ONE SYDNEY HARBOUR

BARANGAROO

R4B SUPPLEMENTARY DESIGN STATEMENT TO SUPPORT S4.55 MODIFICATION
June 2020

Approved Podium South Facade

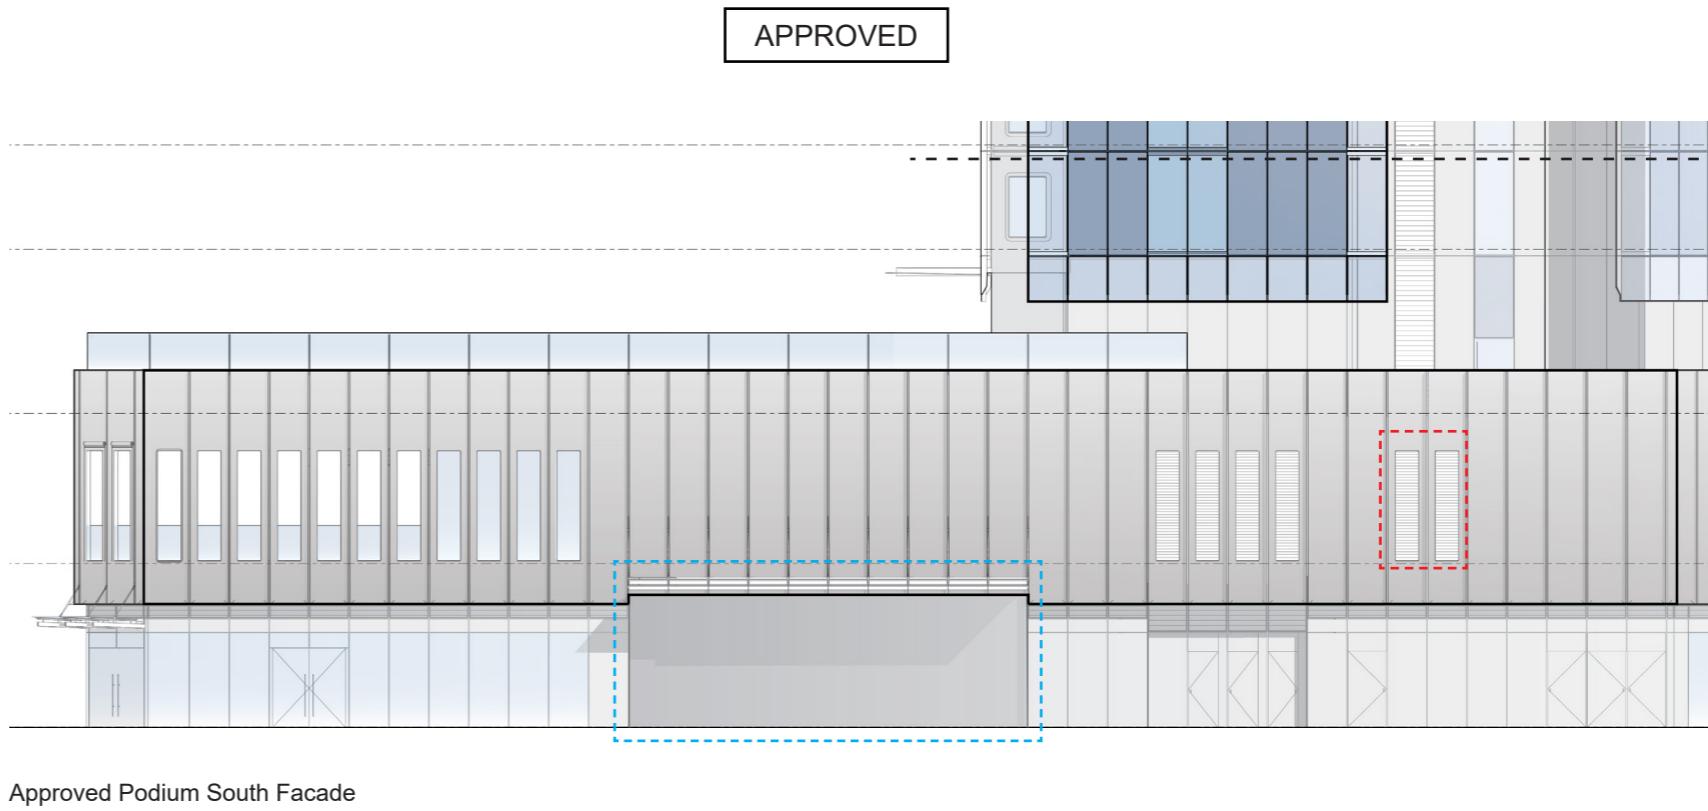
After some developments in the building services a few changes were done in the plantroom areas in P1 and in the garage ramp. Those consequently had some effects on the podium façade, that was amended to better respond to this new context. All changes can be seen in the following south elevation.

The first one is the removal of two louvres panels. Those were rendered not useful after some equipment change in the plantroom they interface with.

Approved Garage Ramp Plan

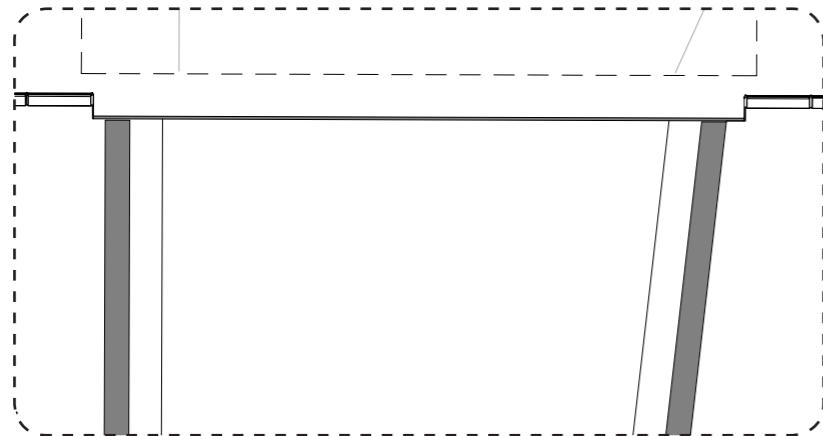
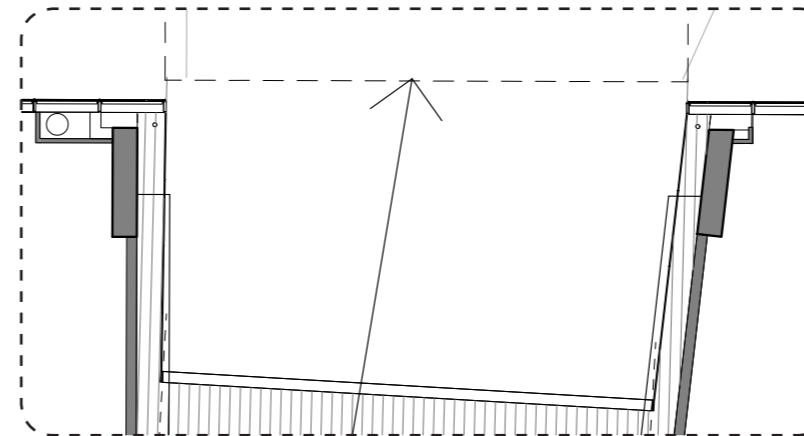
It is proposed that the access to the garage would be better serviced with a bi-folding door instead of the approved shutter blinds. This door configuration is seen as a more refined and reliable solution in tune with the high level of the OSH development.

Locating the door to align with the facade created a number of issues such as interference with the slab edge. With the door likely to remain open during the day, it would create an unnatural overlap with the horizontal elements, particularly the awning. Ultimately this would compromise the clear read of the architectural elements.

All things considered, we believe the best solution is to have the door pushed back, effectively clearing the awning. The space created from the façade line to the garage door is proposed to be clad in aluminium, matching the adjoining façade in materiality. Finally, a added benefit with this scheme was to give the cars a place to pull in off the road while waiting for clearances and the door to open.

A second consequence of this change is the reduction of the garage opening (and awning above) by one module on each side as shown in the following images.

Approved Main residential lobby and Water Feature

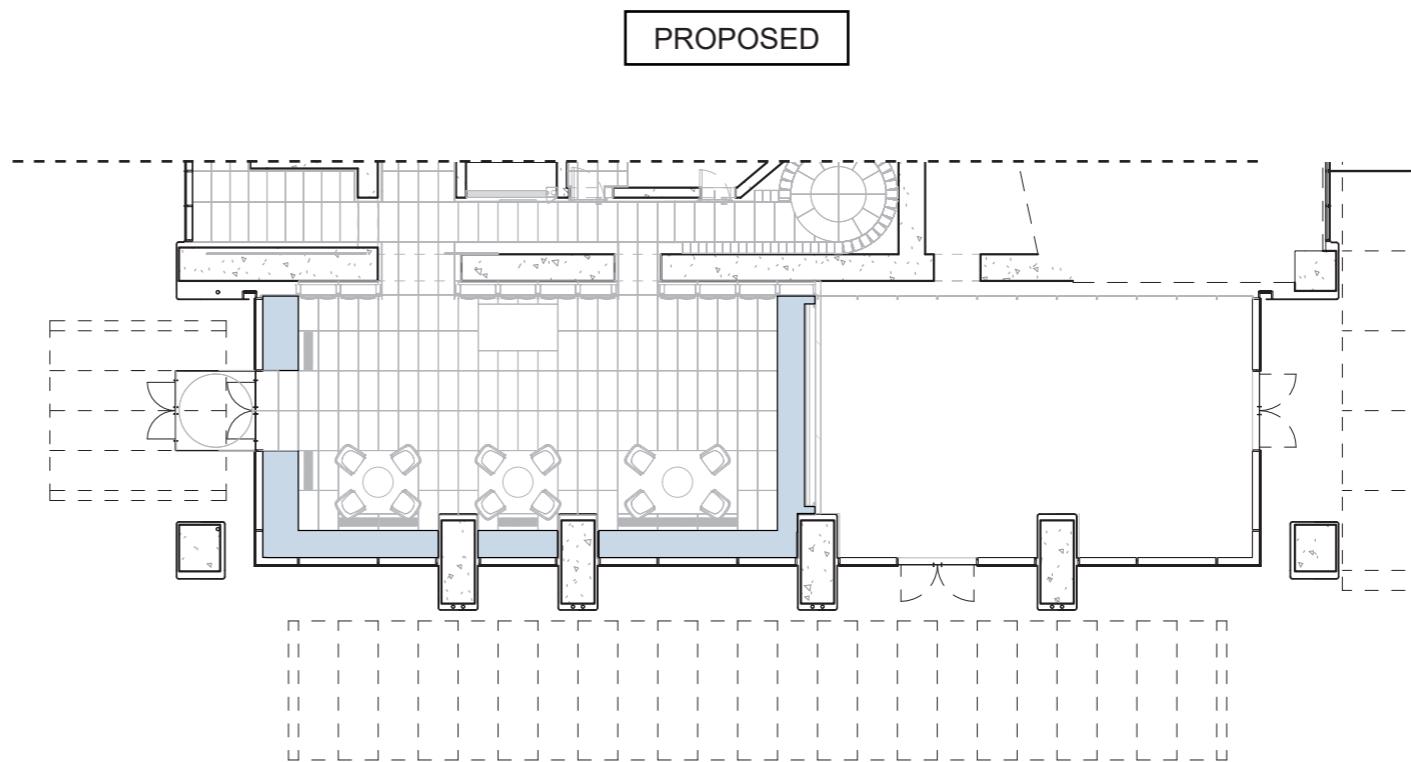
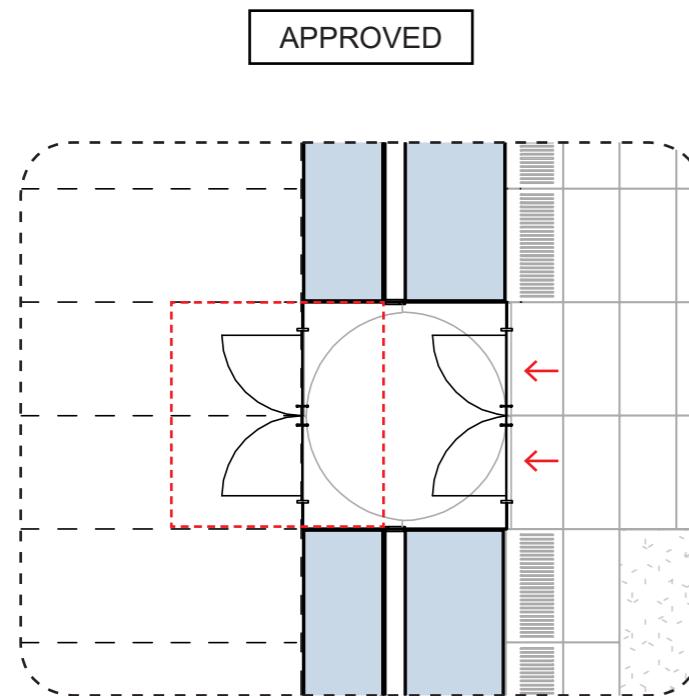
Previously, the water feature spanned both internally and externally, with the façade sitting in the middle. The external wet-stone created some challenges that were perceived as a risk to the optimal user experience. The strong winds, typical of the harbour area, posed a constant issue of blowing the thin film of water onto the pavement or façade, creating overall nuisance and increasing pressure on cleaning and maintenance. Moreover, given the residential lobby was adjoining to a retail area the water was limited only to a portion of the building. From the outside, this could create some inconsistencies perceived by the pedestrians walking along the park façade.

The original conceptual intent of this element was to create a “water trench”, crossed by the entry vestibule, inside of which the residential lobby would appear as an “island”. To emphasise this concept while simultaneously resolving the issues relating to its external counterparts, we proposed a 3-sided water feature. This more clearly defines the lobby “island”, surrounded by water readily perceived by the user, ultimately creating a more compelling design in that area.

Proposed Entry vestibule - Plan

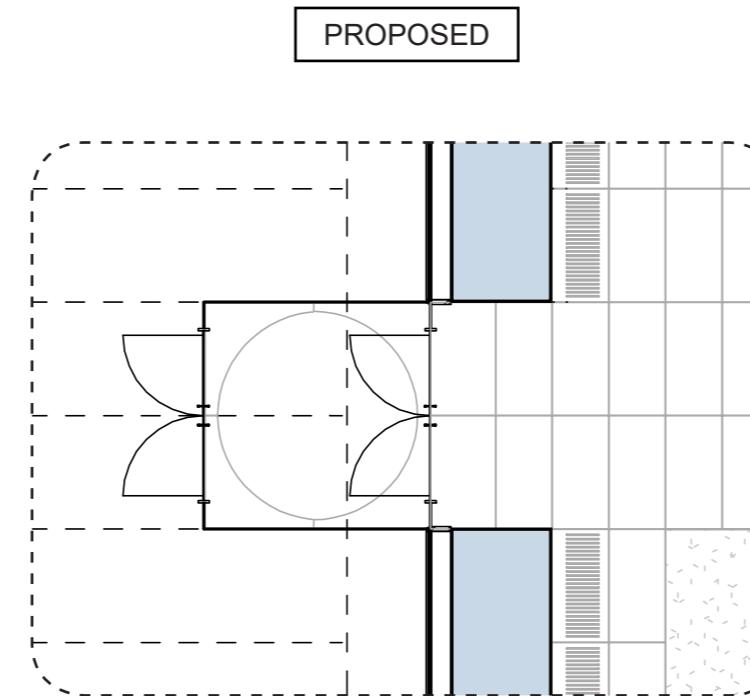
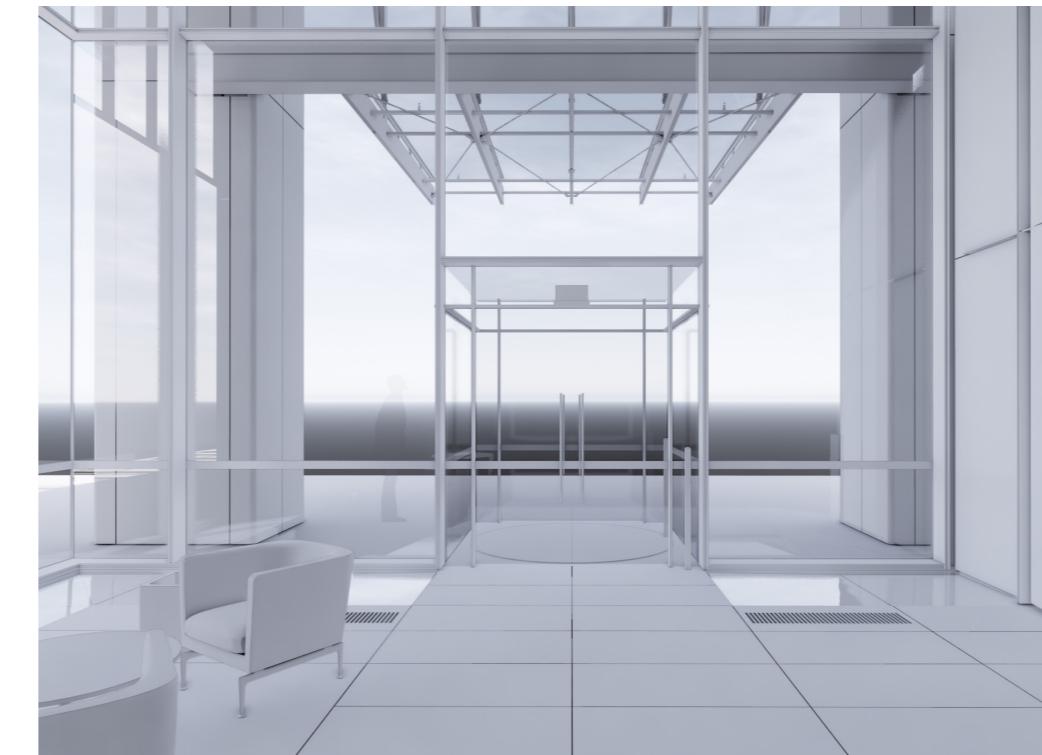
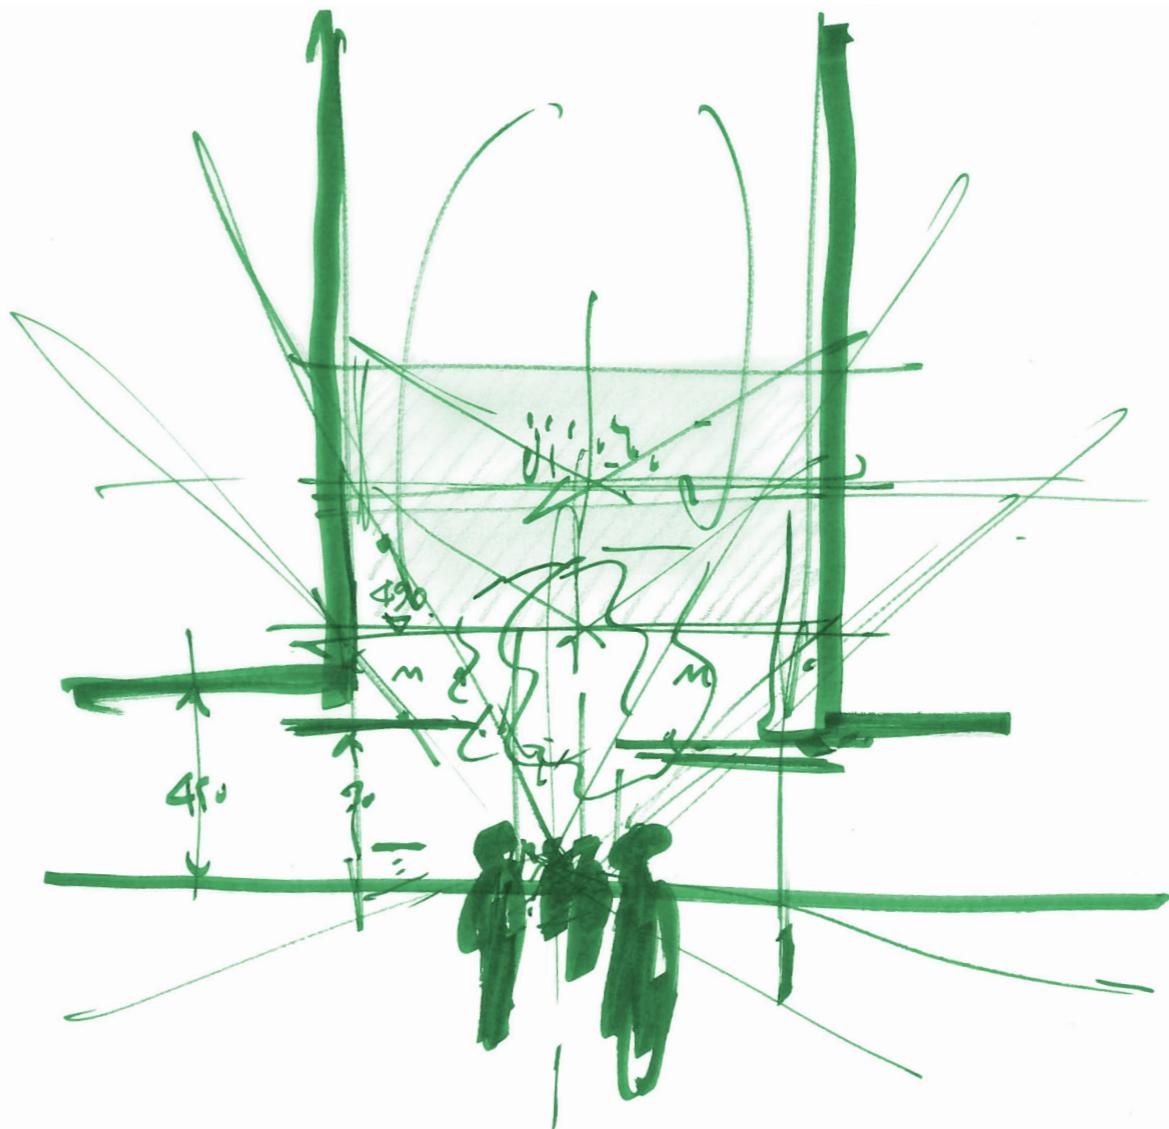
Previously, the glass box, was set centred with the facade glazing. Conceptually it acted as a bridge, having its' extension matching that of the water feature.

In this proposal the glass box is shifted roughly 1.2m outwards. By doing so, it is now positioned completely outside of the water boundary. Paradoxically, without the glass surroundings, this allows the user to better perceive the crossing of the water perimeter, further strengthening the “island” original concept mentioned at section 2.4.1.
